IFB No. **23-37 Security Vestibules at Flinn, Guilford, Lincoln, Nashold & Summerdale Schools**

RE: **ADDENDUM NO. 1**

ADDENDUM ONE

Project: **SECURITY VESTIBULE AT
VARIOUS SCHOOLS FOR
ROCKFORD PUBLIC SCHOOL DISTRICT #205
ROCKFORD, ILLINOIS**

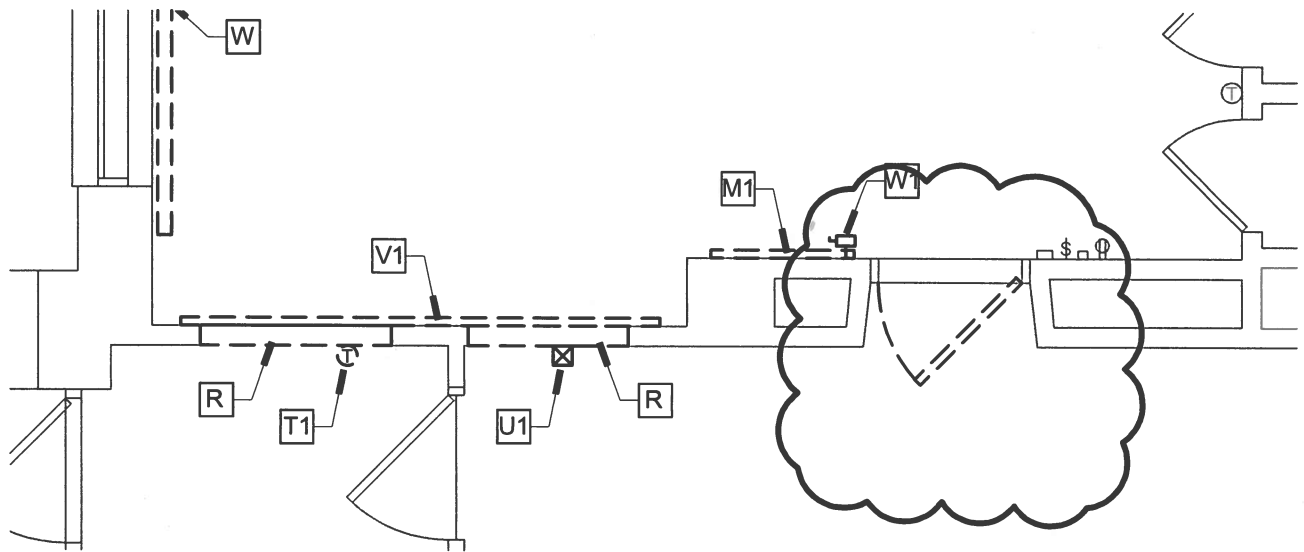
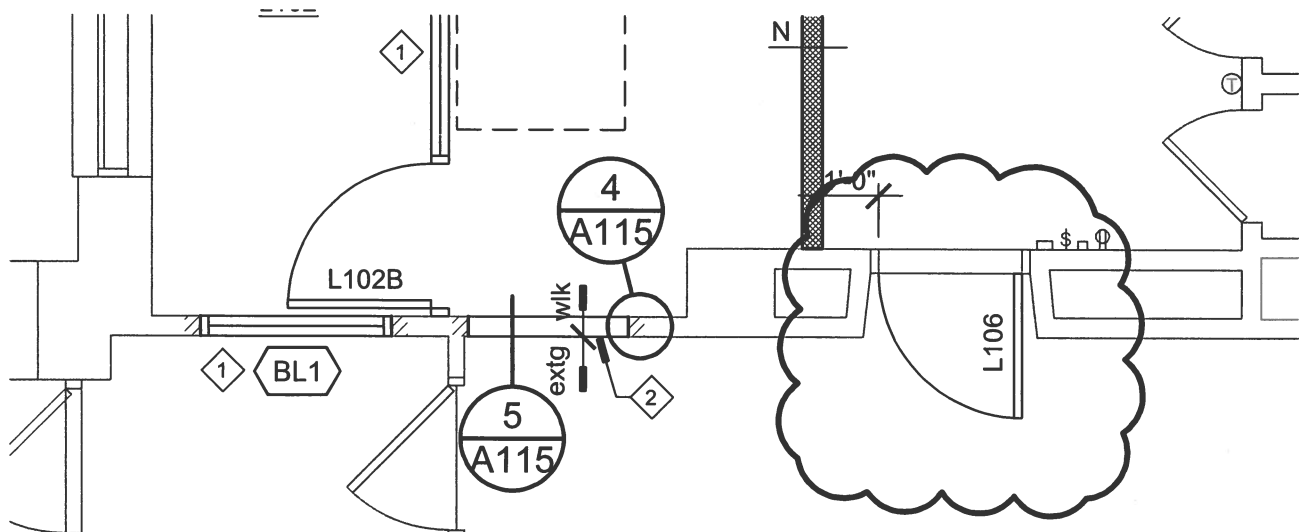
5.1. Existing door and hardware to classroom shall be removed. Patch in wood stop and stain to match existing. Modify existing door frame as required. See addendum drawing ADA1.1.

6.1. Provide and install new wood door and hardware to Conference Room L106. See addendum drawing ADA1.1.

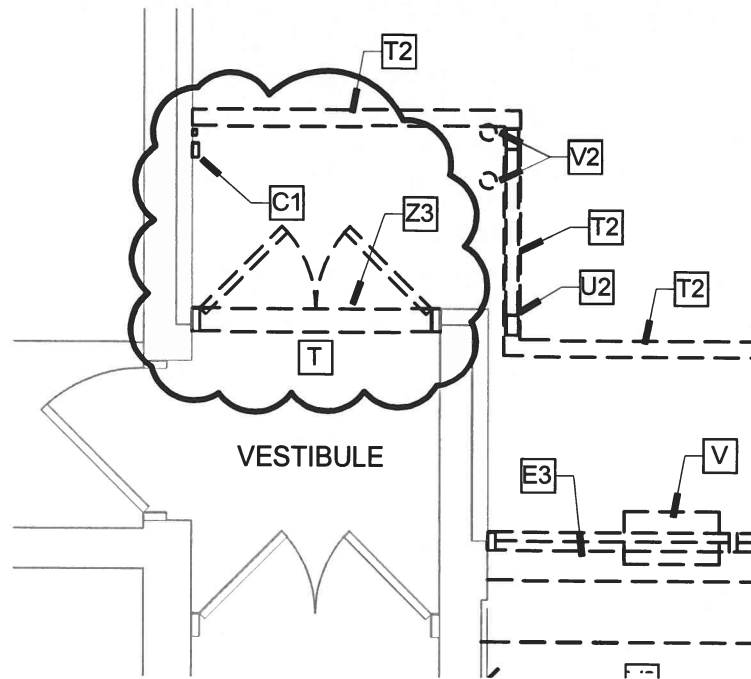
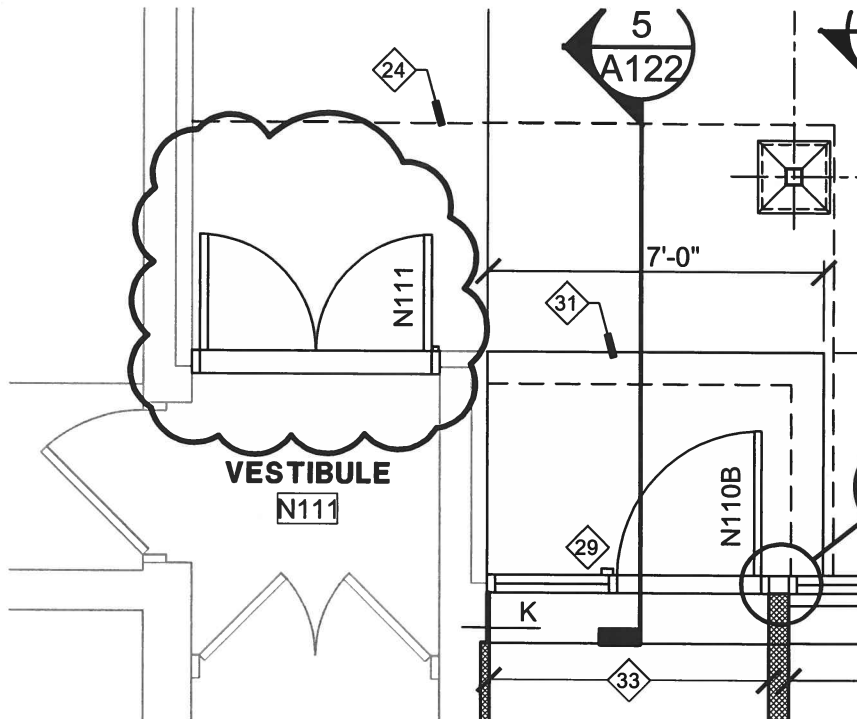
8.1. Existing main entry doors, frame and hardware shall be removed. See addendum drawing ADA1.3.

9.1. Provide and install new aluminum doors, frame and hardware. See addendum drawing ADA1.3.

ADE1.1

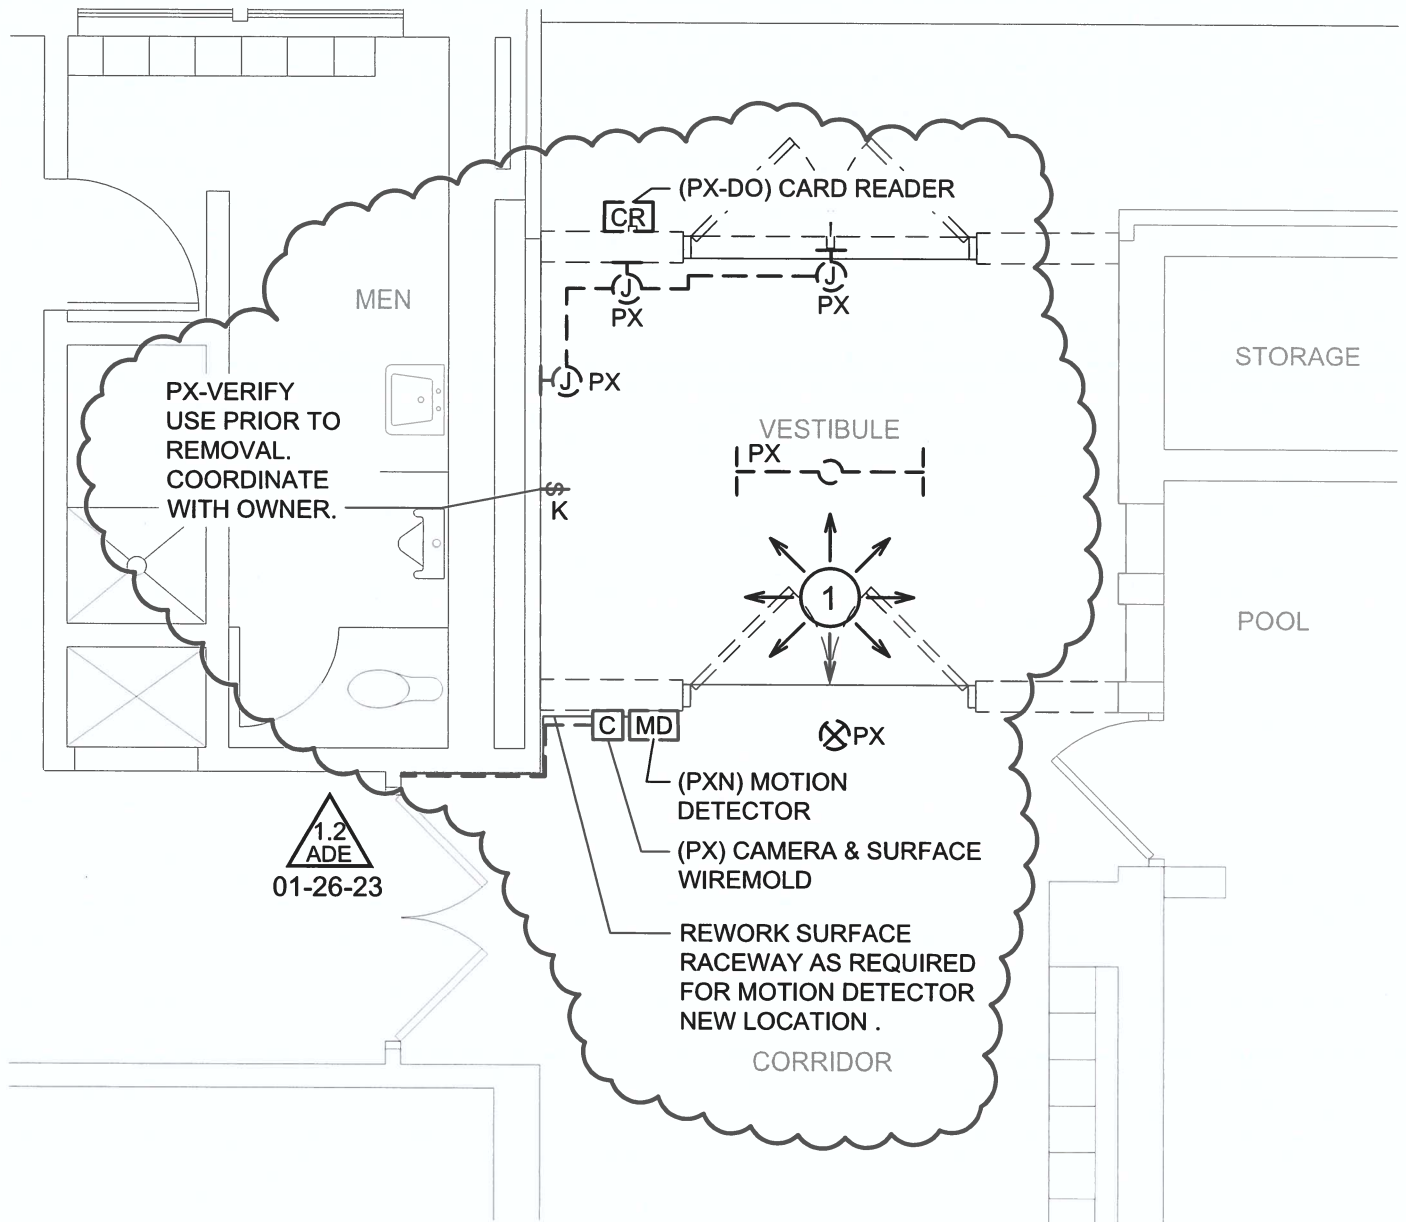
12.1. See Addendum Drawing ADE1.1 showing exterior soffit junction boxes and conduits required to be relocated to maintain accessibility with new enclosed soffit.

ADE1.2

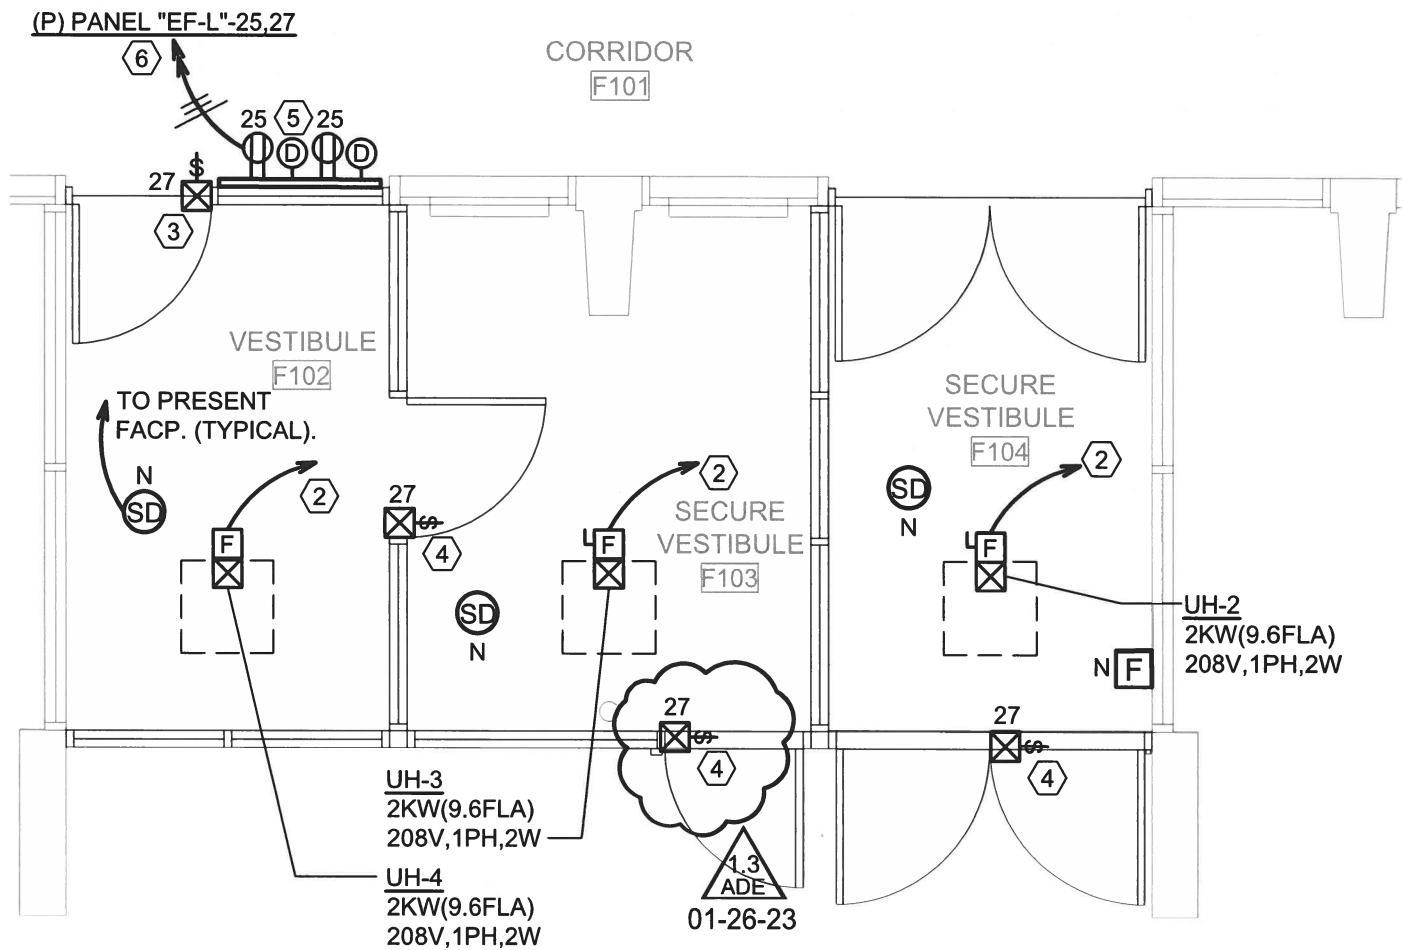
13.1. See Addendum Drawing ADE1.2 showing additional electrical demolition work in the vestibule.

ADE1.3

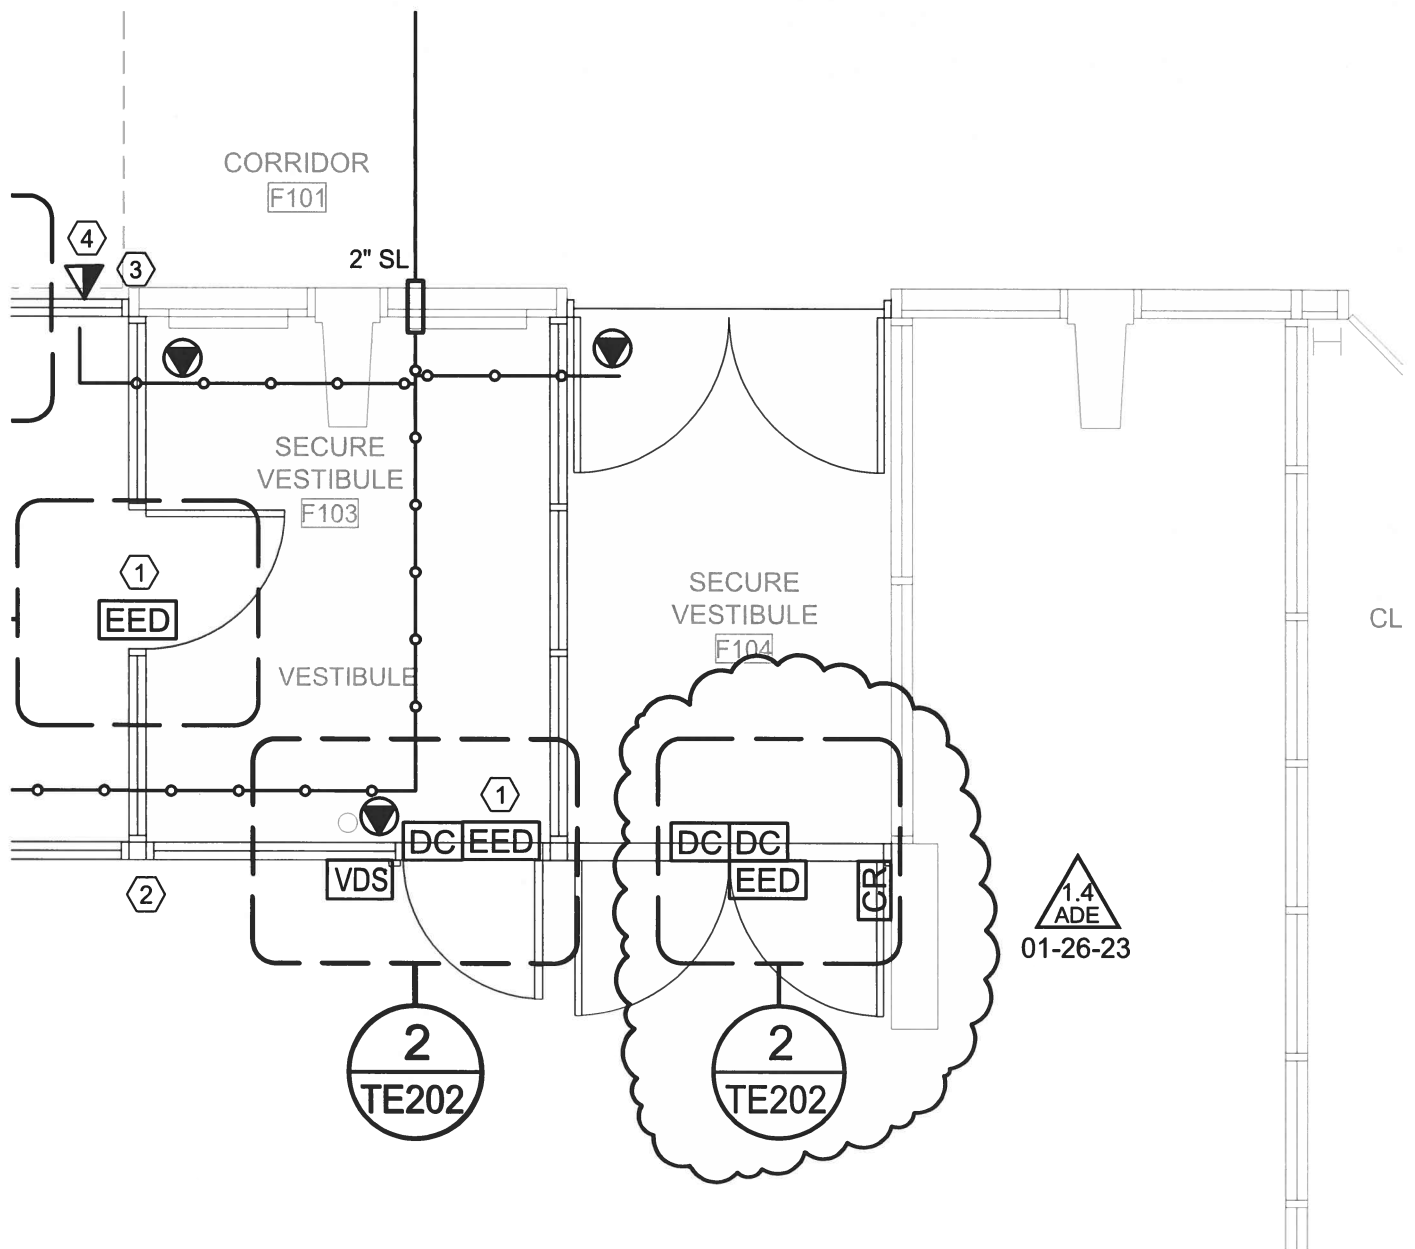
14.1. See Addendum Drawing ADE1.3 for revised Drawing Keynote number.

ADE1.4

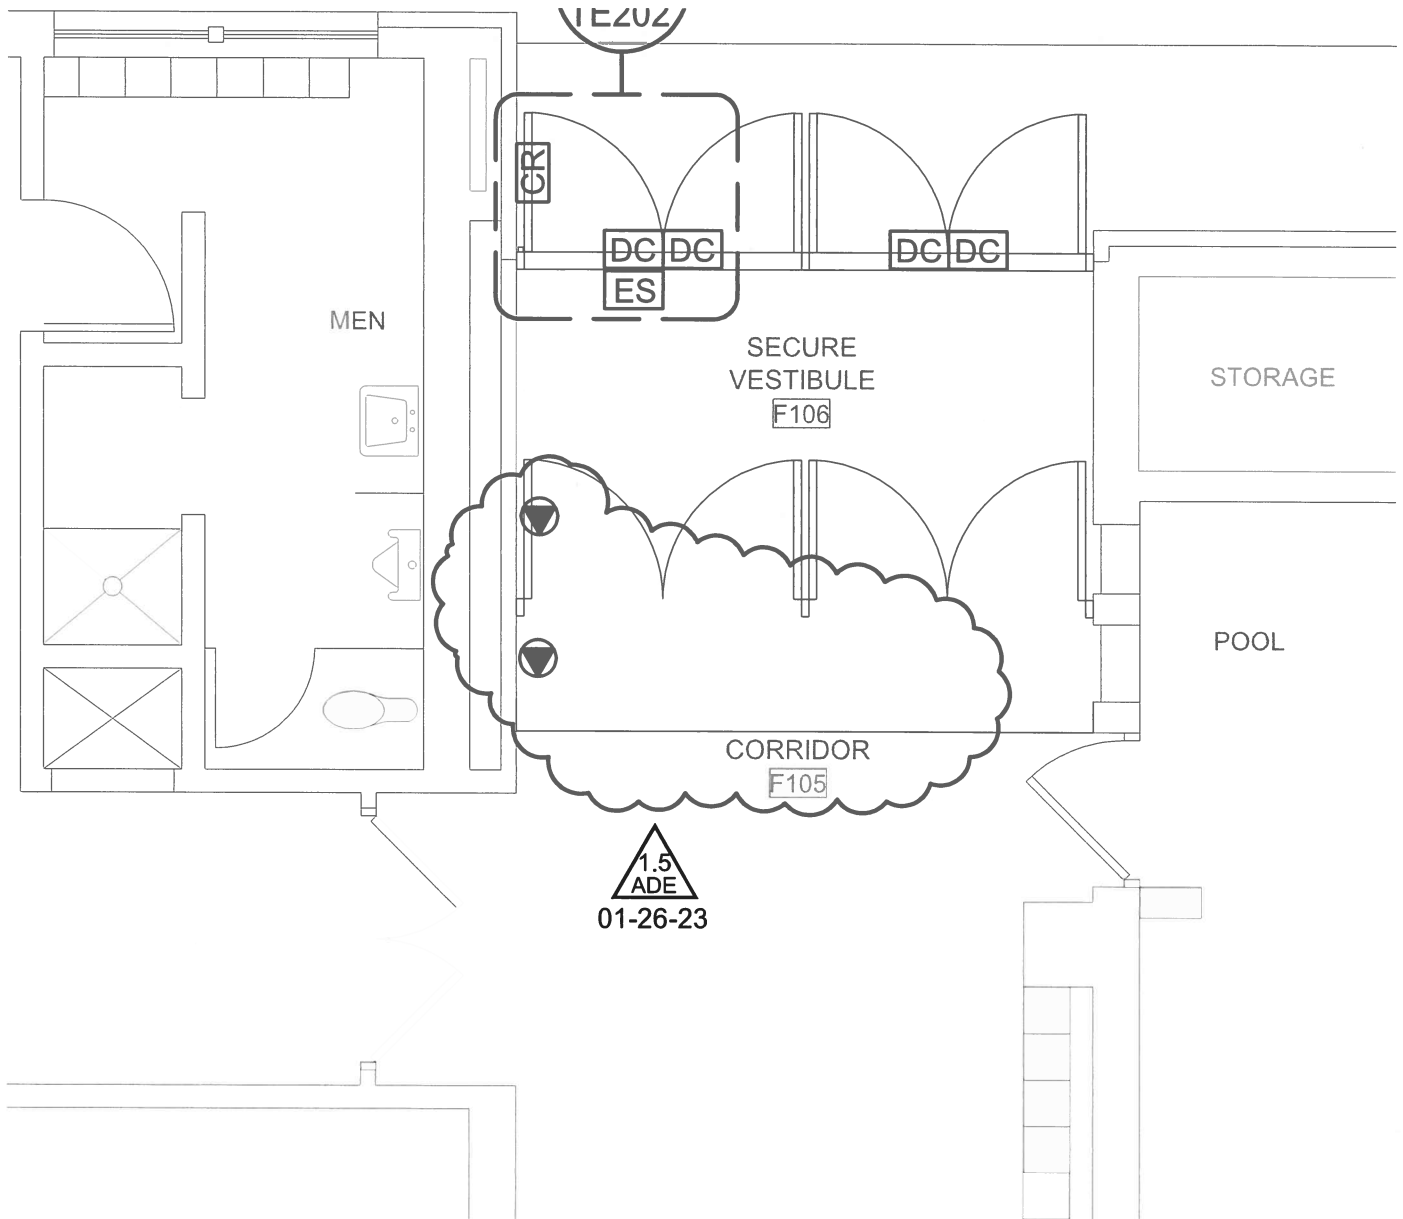
16.1. See Addendum Drawing ADE1.4 for revised door hardware type.

ADE1.7

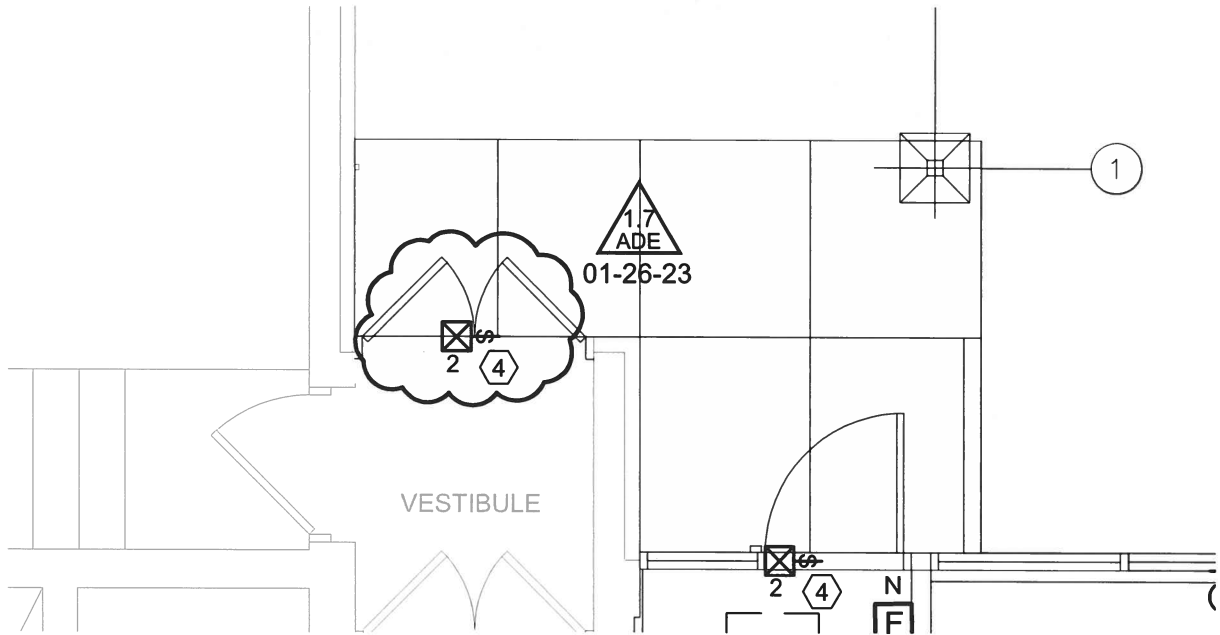
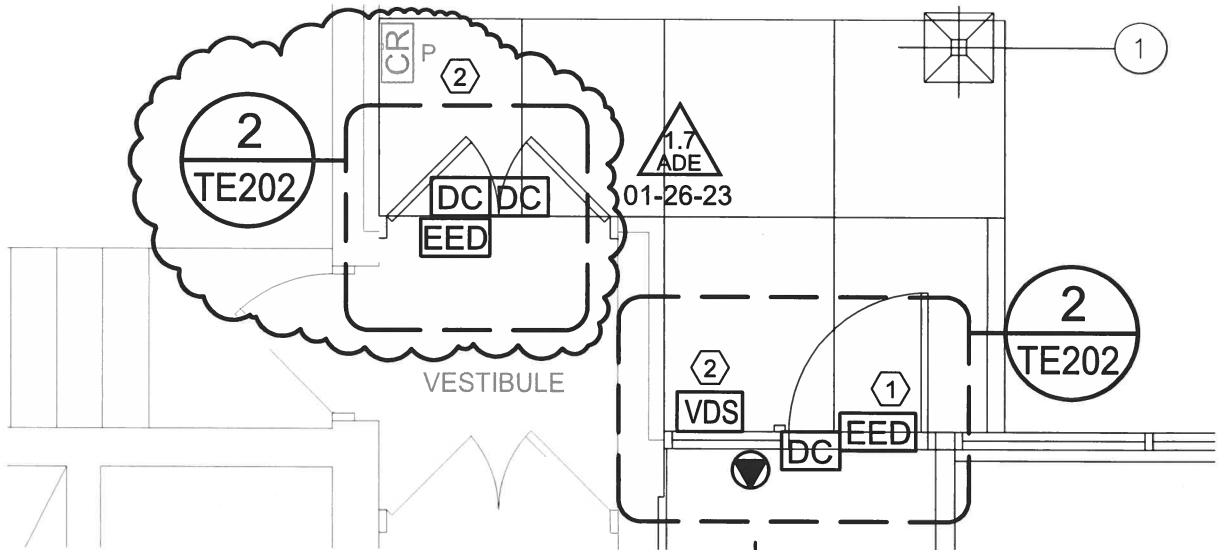
15.1. See Addendum Drawing ADE1.6 for additional demolition and new work required for door replacement.

15.2. See Addendum Drawing ADE1.7 for electrified exit device power.

17.1. See Addendum Drawing ADE1.7 for access control devices for new door.
